**HUDSON RIVER PCBs REASSESSMENT RI/FS  
RESPONSIVENESS SUMMARY FOR  
VOLUME 2A: DATABASE REPORT  
VOLUME 2B: PRELIMINARY MODEL CALIBRATION REPORT  
VOLUME 2C: DATA EVALUATION AND INTERPRETATION REPORT**

**DECEMBER 1998**

**U.S. Environmental Protection Agency  
Region II  
and  
U.S. Army Corps of Engineers  
Kansas City District**

**TAMS Consultants, Inc.  
Limno-Tech, Inc.  
TetraTech, Inc.  
Menzie-Cura & Associates, Inc.**

Figure DC-4.6  
 Relative Fractional Difference for Phase II  
 Water Column Split Samples (Total PCBs)

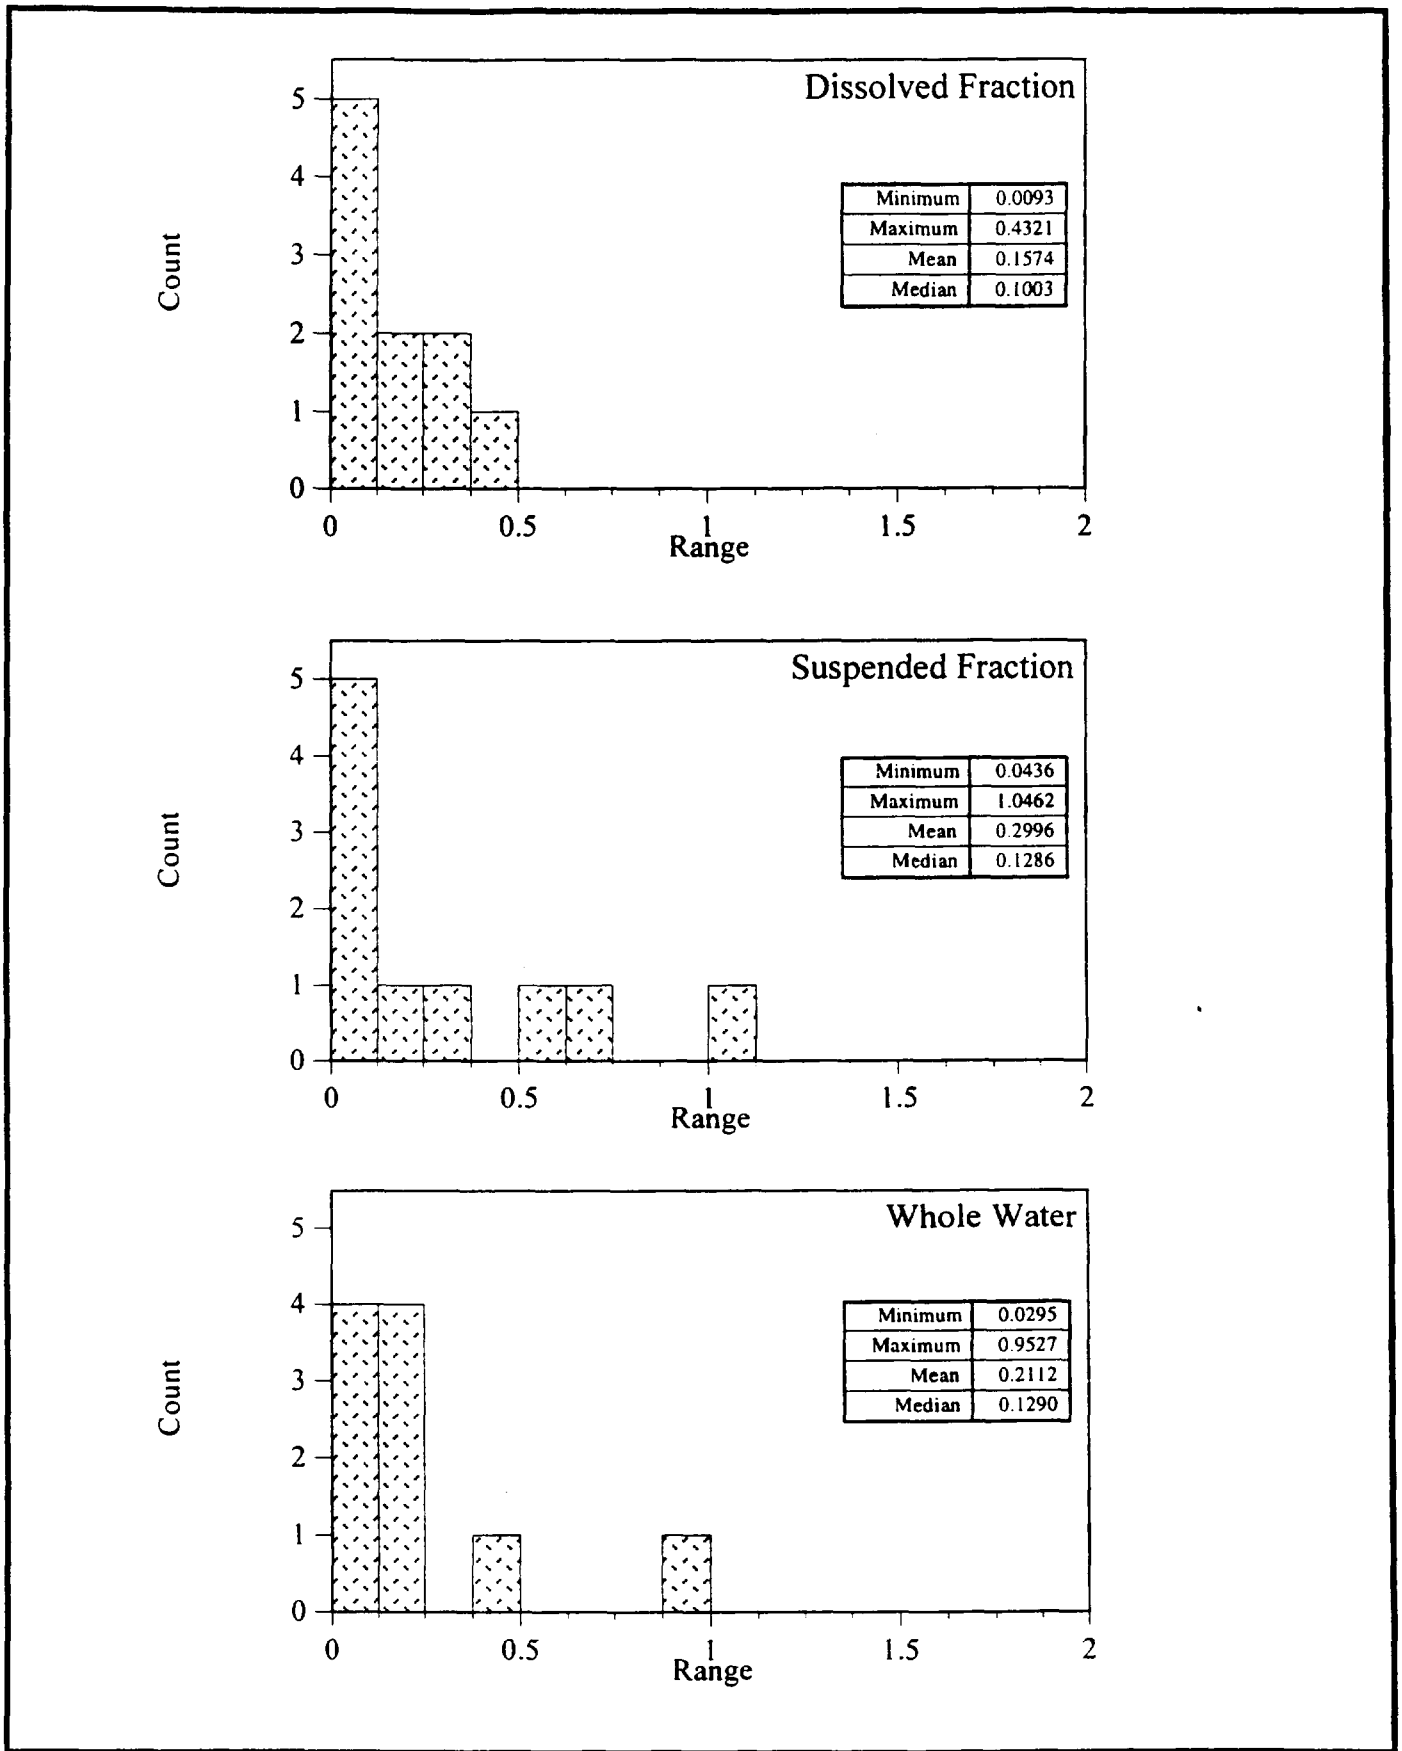
##### Response to DC-4.6

The precision in the Phase 2 sampling methods is determined by comparing the split sample data. Figure DC-4.6 shows the relative fractional differences of the ten split samples analyzed for total PCBs taken during the flow-averaged and transect events. Although the distributions are right skewed, the median values are low at 0.10, 0.13, and 0.13 for the dissolved, suspended and whole water samples, respectively. Each sample required a large volume of water in order to achieve the low quantitation limits for PCBs, which in turn necessitated a long sampling period. This may be the cause of the occasional high relative fractional difference.

**Figure DF-2.7**  
**General Electric Hudson Falls Source - Seepage Homologue Distribution, May 1993**

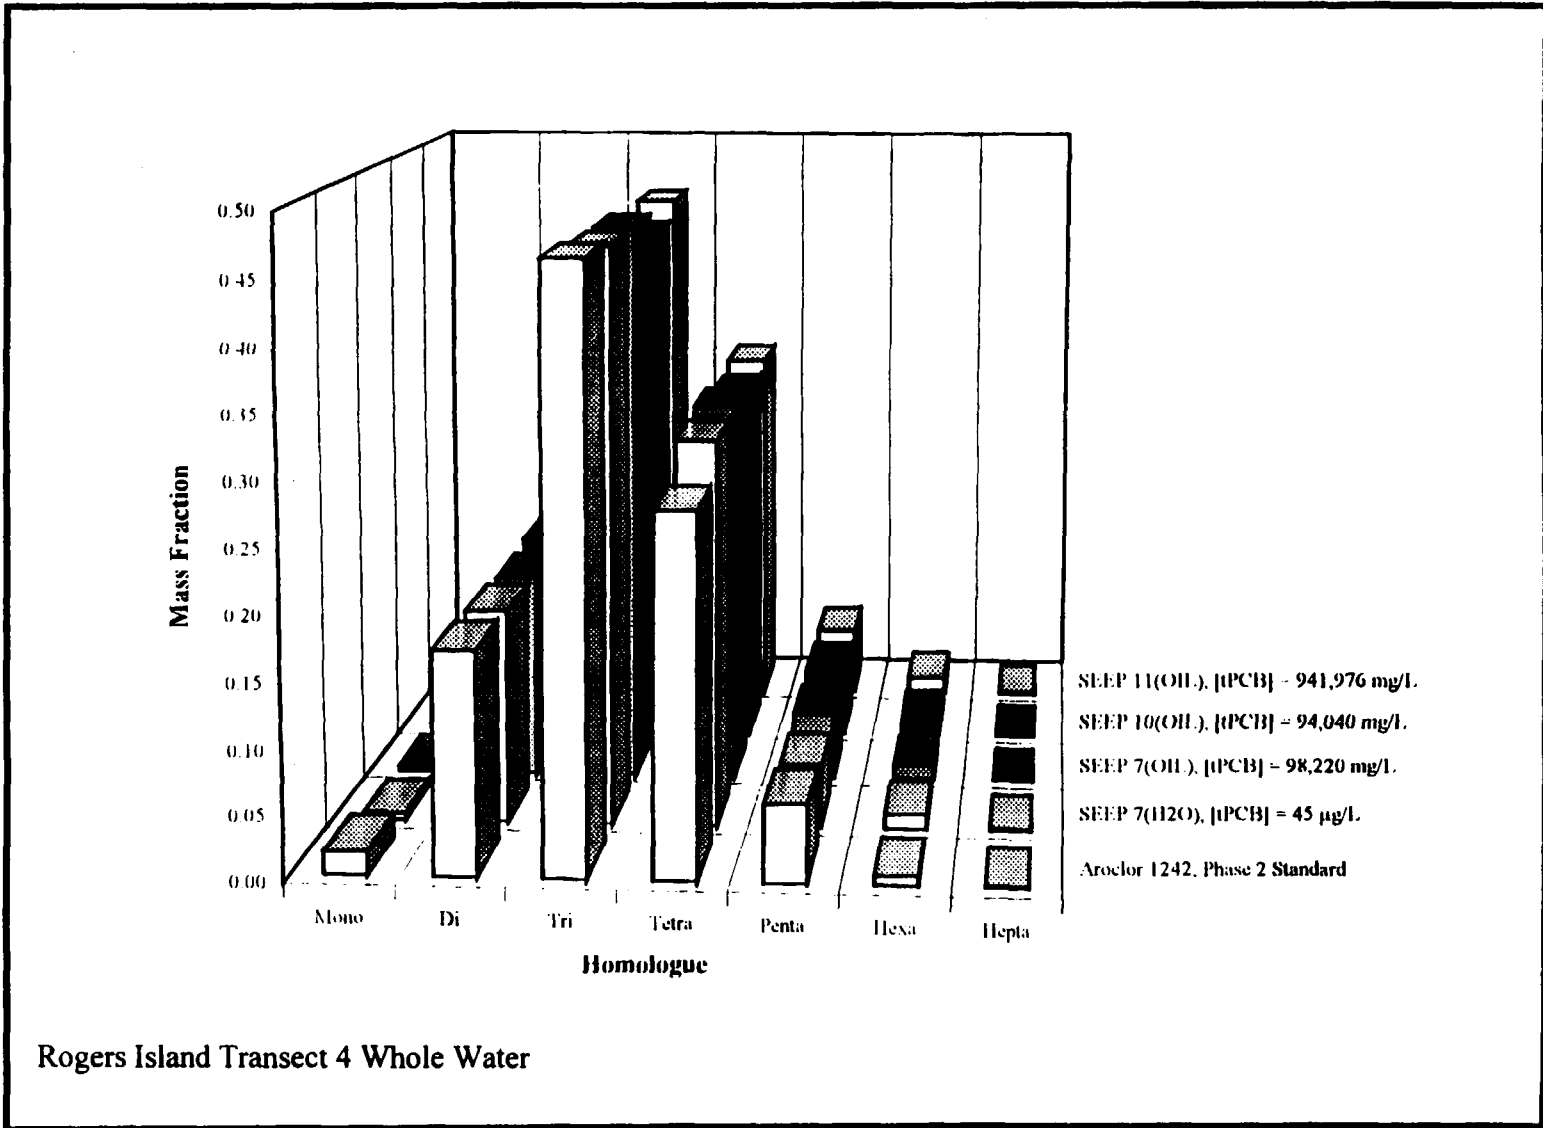
##### Response to DF-2.7

Figure DF-2.7 provides a comparison of the PCB homologue distribution in both the non-aqueous phase liquid and water phases of seepage samples collected in May 1993 from the eastern raceway area adjacent to the GE Hudson Falls facility with the USEPA Phase 2 Aroclor 1242 standard as well as the whole water sample collected at Rogers Island during the spring runoff event of 1993. As can be seen, the sample patterns closely resemble the standard, suggesting that the mixture is primarily Aroclor 1242. However, as shown by the H, H' congeners in Figure DG-1.20B (in Section 4.3.2), there are still significant differences between the Rogers Island station and pure Aroclor 1242. The results shown in Figure DG-1.20B show substantially higher levels of three of the four congeners presented, indicating the presence of a heavier Aroclor mixture (*e.g.*, Aroclor 1254) in the GE releases.

Figure 3.2.2A  
 Fort Edward to Stillwater Incremental Summer Average Flow vs.  
 Total Precipitation for Glens Falls

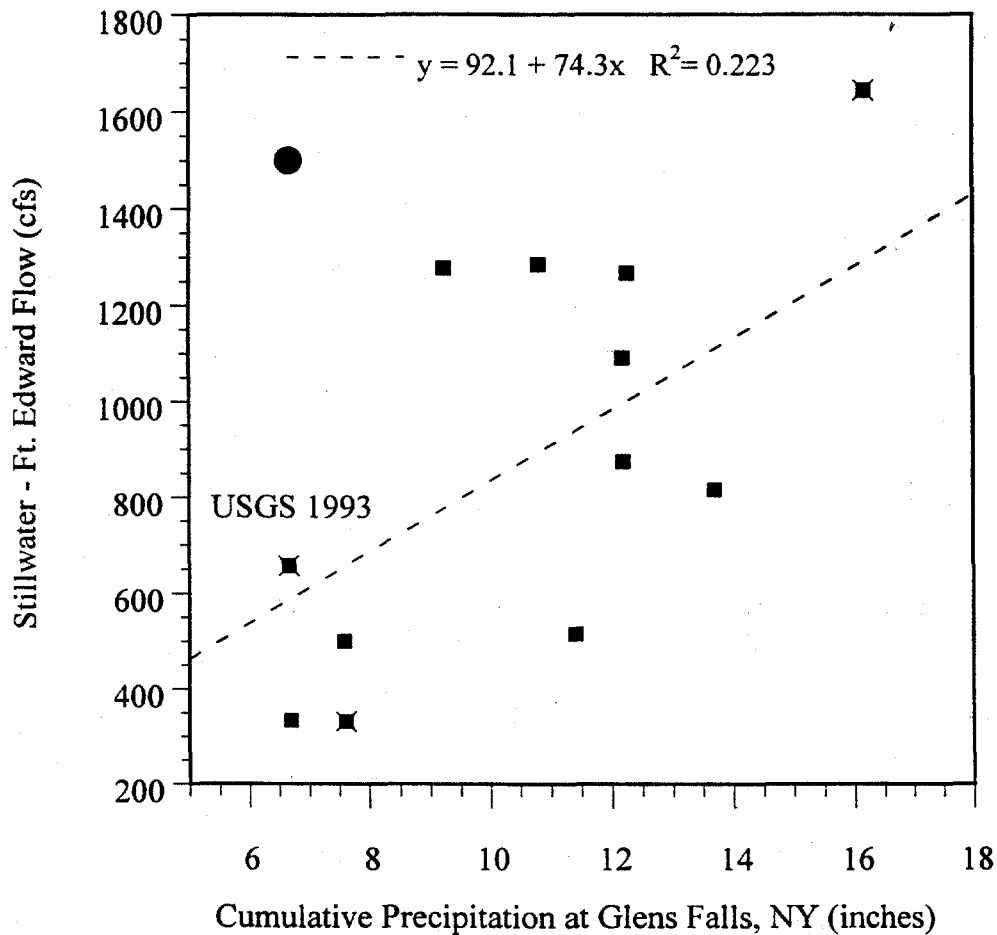
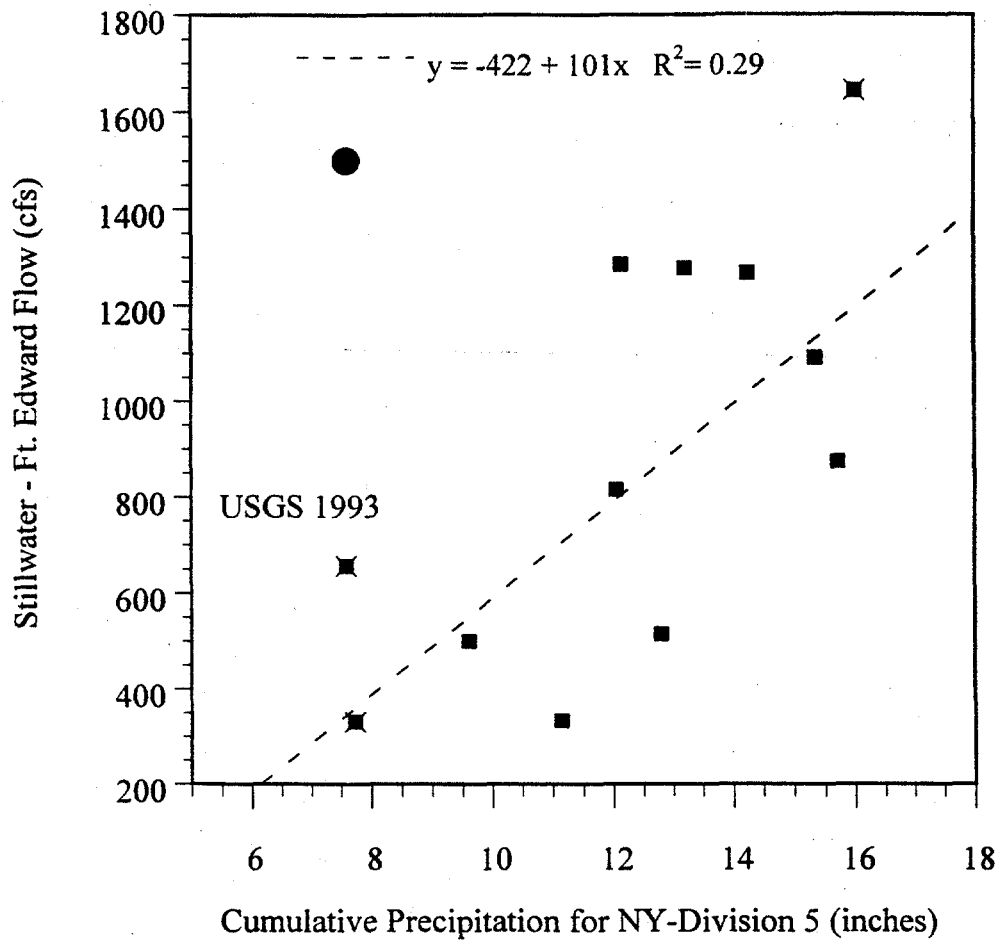
#### Correction to Section 3.2.2 - Flow Estimation

As part of the original data analysis, estimates of flow in the Upper Hudson between Schuylerville and Waterford were required due to the loss of USGS discharge stations at Stillwater and Waterford. These stations were lost due to construction activities in the corresponding areas of the river. In order to obtain flow estimates, staff gauge data from the NYS Champlain Barge Canal system were analyzed and used to estimate flow, as reported in the DEIR.

Since the original preparation of the DEIR, additional information concerning Hudson River flows between Schuylerville and Waterford during 1993 have become available. Specifically, USGS estimates of water flow based on other data for the region have been published as well as additional information on the nature of the modifications made to the dams in this region of the river. Additional information concerning the barge canal staff gauge data was also obtained which suggested that several of the staff gauges used in the flow analysis may have been affected by the construction as well.

The subsequent choice of the "correct" flow records was based on the precipitation records for the Upper Hudson area. A comparison of the flow and precipitation data was prepared which established the relationship between flow and precipitation for the historical data prior to the construction begun in 1993. This result is shown in DEIR Figures 3.2.2 A and B. These figures compare the incremental flow gain between the USGS measurement stations at Fort Edward and Stillwater with two different records of precipitation in the Upper Hudson area. The vertical axis in each graph represents the mean June-to-September flow gain between Fort Edward and Stillwater. Also shown on these graphs are the estimates for 1993 based on the Phase 2 and USGS analyses. It is clear from these diagrams that the USGS estimates are in closer agreement with the historical relationship than is the Phase 2 estimate. In light of this finding as well as the information concerning the dam construction work in the region, the USGS estimates of flow at Stillwater and Waterford will be used in subsequent Reassessment analyses in place of the Phase 2 flow estimates reported in the DEIR.

**Figure DG-1.15A**  
**Water Column PCB Concentrations Within the Vicinity of Fort Edward**  
**from the 1995 River Monitoring Test**

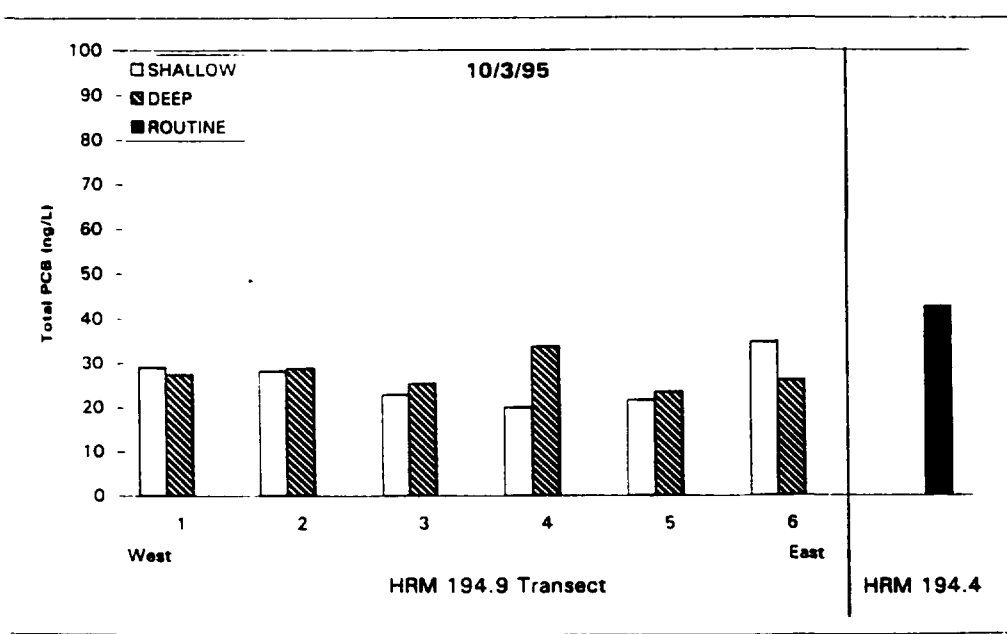
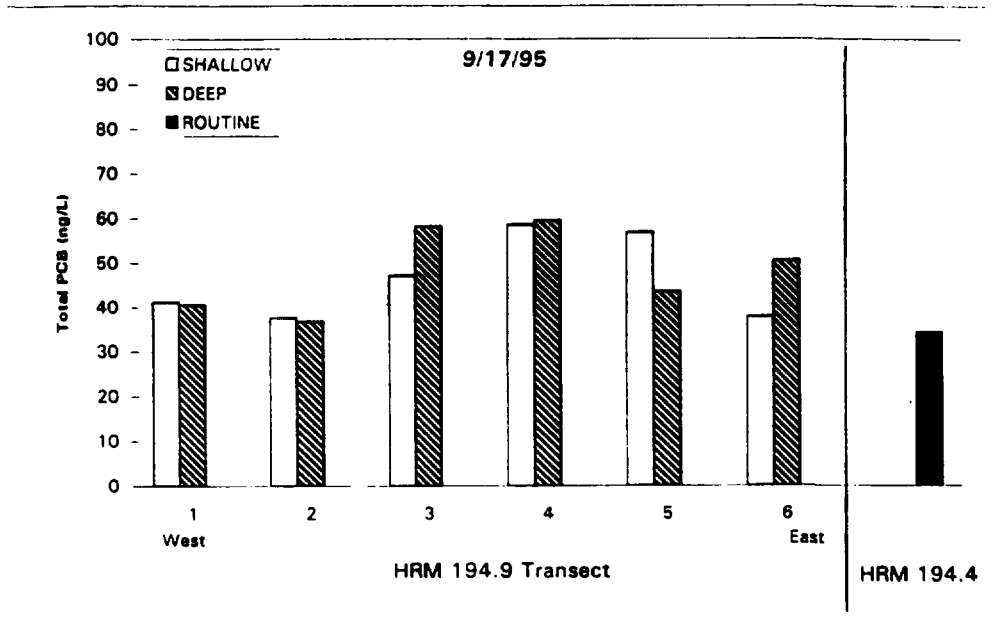
### Response to DG-1.15

In a subsequent report to USEPA (QEA, March 1998), GE demonstrated the homogeneity of the water column load above Rogers Island on two separate occasions by collecting shallow and deep samples at several locations in a river cross-section (see Figure DG-1.15A). Water column concentrations both horizontally and vertically rarely varied more than 25 percent and typically

agreed to within 10 percent. The data also showed that the normal Rogers Island monitoring station agreed with these cross sections within reasonable bound, falling 25 percent lower and 58 percent higher on the two sampling events. The close vertical agreement of the water column samples is strong evidence for the absence of the oil droplets at the river bottom, since they would presumably raise the concentration of the deeper water relative to the shallower water. Additionally, the data show that the water column load originating in the Hudson Falls area has been thoroughly homogenized in the water column by the time the load reaches Rogers Island. This is further evidence of the accuracy of the Rogers Island monitoring station.

In view of this, it appears likely that the Rogers Island monitoring results will on average accurately represent the loads entering the TI Pool.

Figure DG-1.15D  
Water Column PCB Concentrations at Bakers Falls Plunge Pool and  
Fort Edward from Hydrofacility Monitoring Program

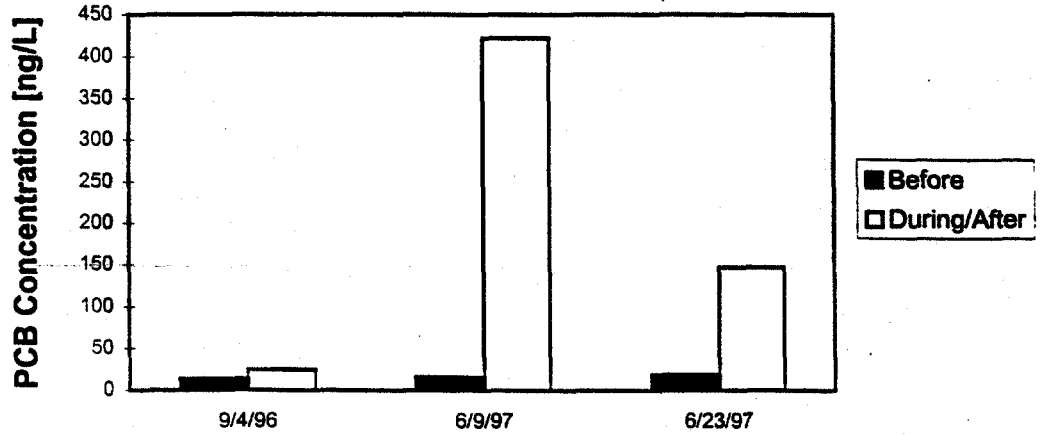
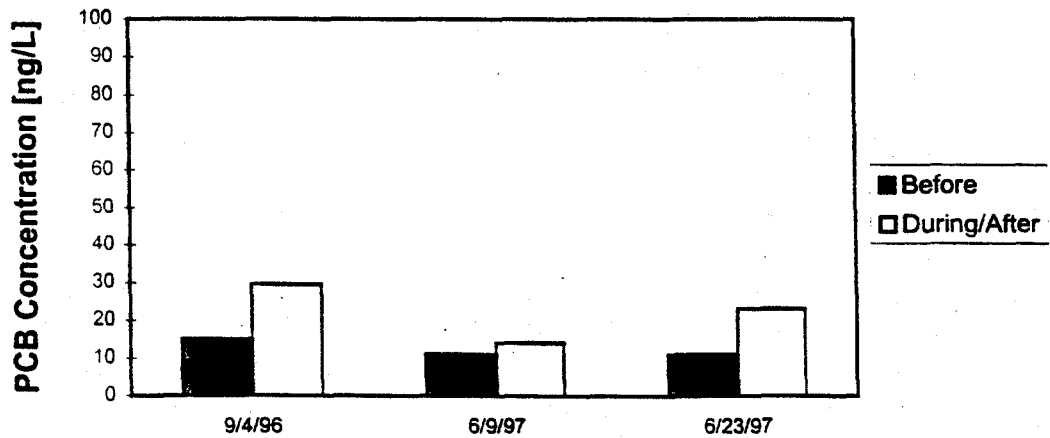
#### Response to DG-1.15D

The hydro plant flushing activities were studied by GE and reported to USEPA (QEA, March 1998). These studies show small increases in the PCB loads delivered to Rogers Island as a result of these activities. Some results are shown in Figure DG-1.15D. These events serve to create highly concentrations near the plunge pool which are subsequently homogenized by the transit to Rogers Island. Thus, although these events do add to the PCB loads of the Upper Hudson, they do not represent major loads unaccounted for by the Rogers Island monitoring.
